Far East Knitting & Dyeing Industries Ltd. (Building-3 & 4)

Observations

Discrepancies between drawings and on site condition

Steel Column Layout

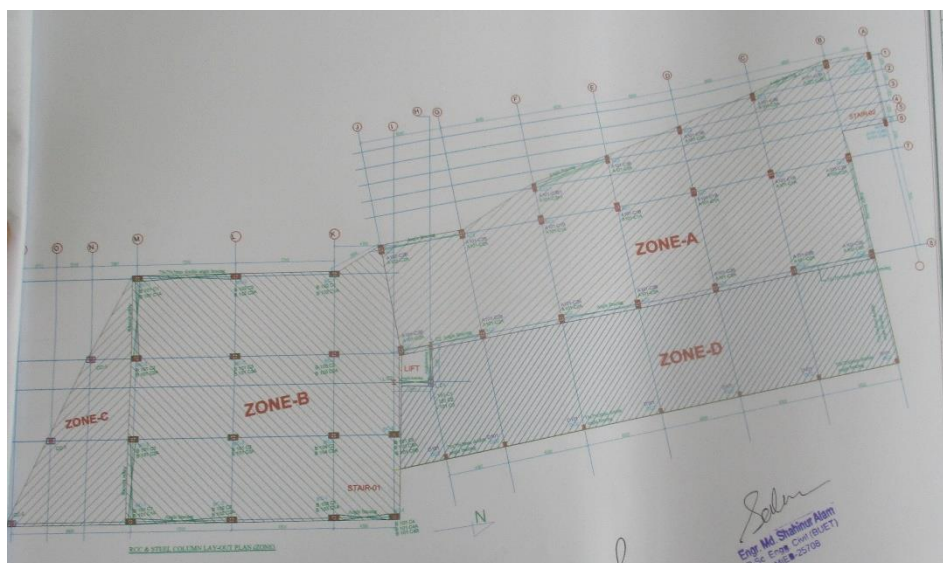
Measured 10 mm thickness of flange instead of 12 mm

Measured 230 mm width of flange instead of 255 mm

Column sizes and thickness not match with provided drawings at zone A for column AC2 & AC3. Building engineer is required to produce an “as constructed” drawings to reflect the actual site dimensions with complete structural information.

Lack of Bracings details

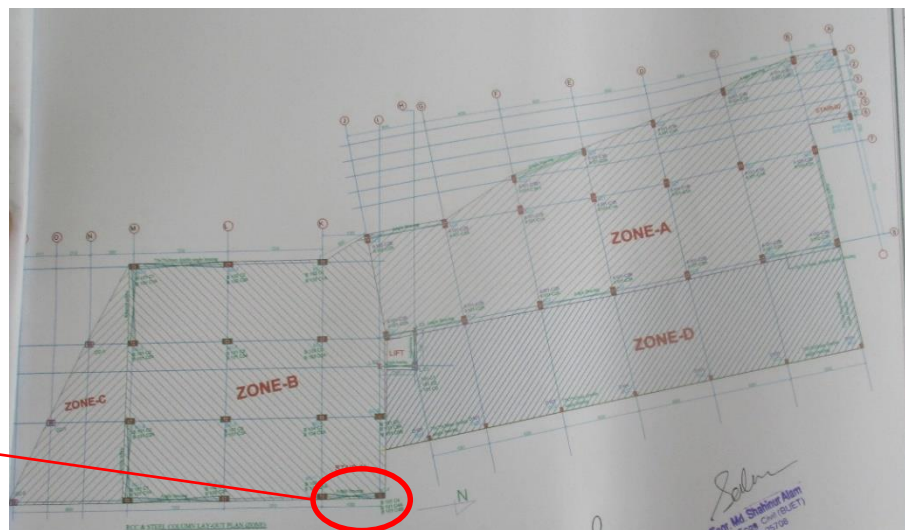
Sectional detail of bracing not found in provided drawings. Bracing is missing at south stair on ground floor.

Bracing missing at stair -1

Bracing were not properly installed at GF

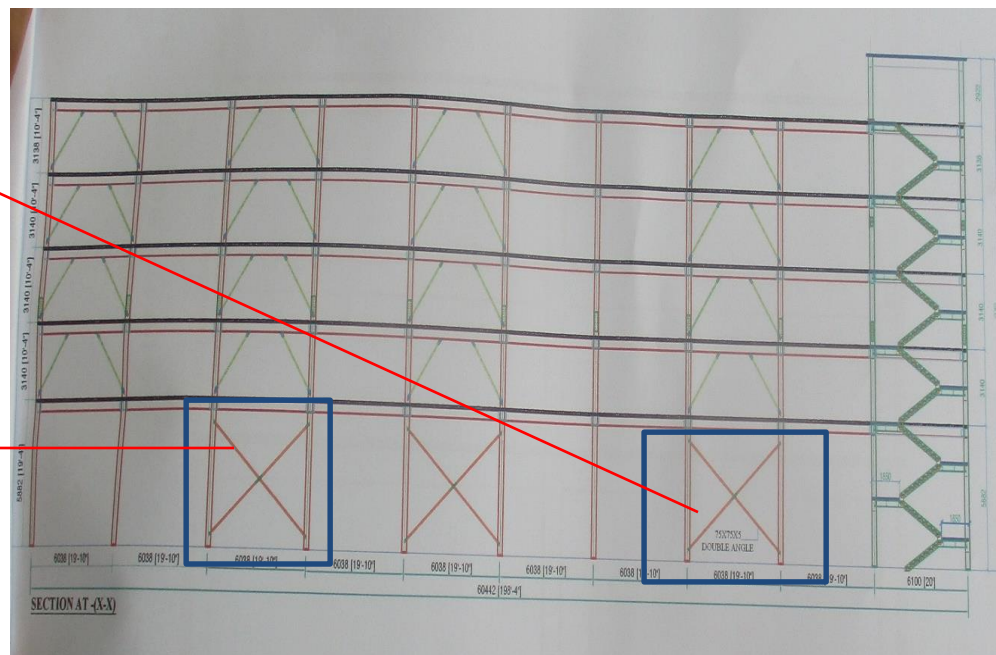
Bracing missing at one direction

Bracings were not installed properly. Bracing was missing at one direction and a bracing was not continued to the column at GF.

Bracing not continued to the column

7	Bracing were not properly installed at GF	Install missing bracing at mentioned location.	6-weeks
8	Lack of waterproofing system on roof	Waterproofing on the roof slab is to be applied. Moreover the roof slab drainage system should be investigated and improved.	6-months

Lack of waterproofing system on roof

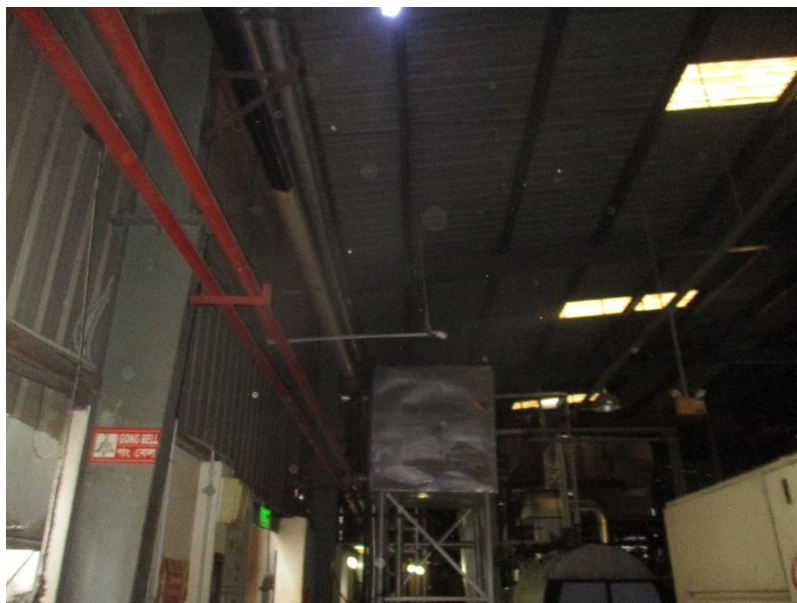
No waterproofing membrane was visible on these roofs. Proper drainage system and water proofing membrane need to apply on roof to resist water ingress into the slab.

Lack of stability system (Generator Shed)

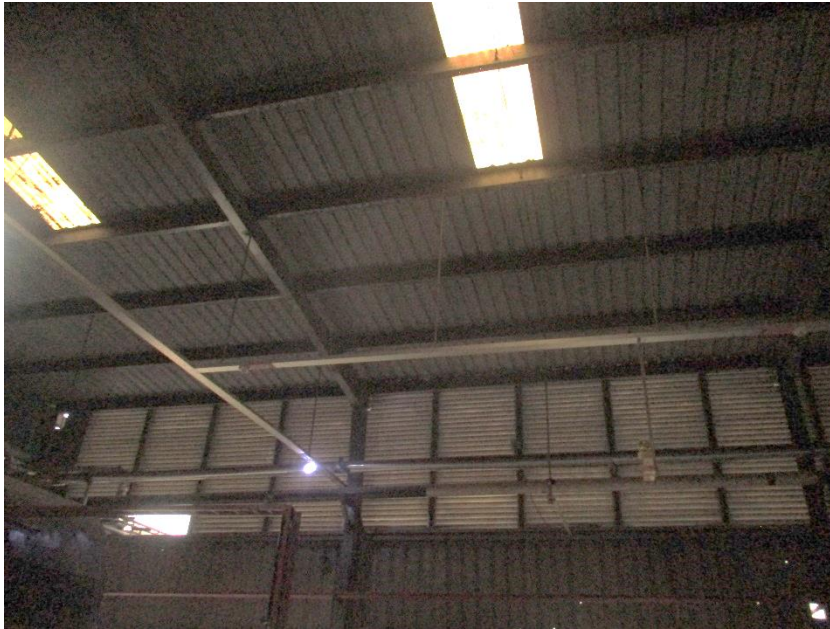
Lateral load transferring media/compression strut was not available in this structure. Also there is no proper bracing system in column and roof. Building engineer to check the stability of the structure under lateral and vertical loading.

No bracing and compression strut was observed.

Item No.	Observation	Recommended Action Plan	Recommended Timeline
9	As-built documentation for Generator shed	Prepare update as-built documentation for all utility buildings.	6-weeks
10	Lack of stability system (Generator Shed)	Building engineer to check the capacity of the structure under lateral and vertical loading.	6-weeks
11	Lack of stability system (Generator Shed)	Carry out remedial works resulting from engineering assessment of building.	6-months
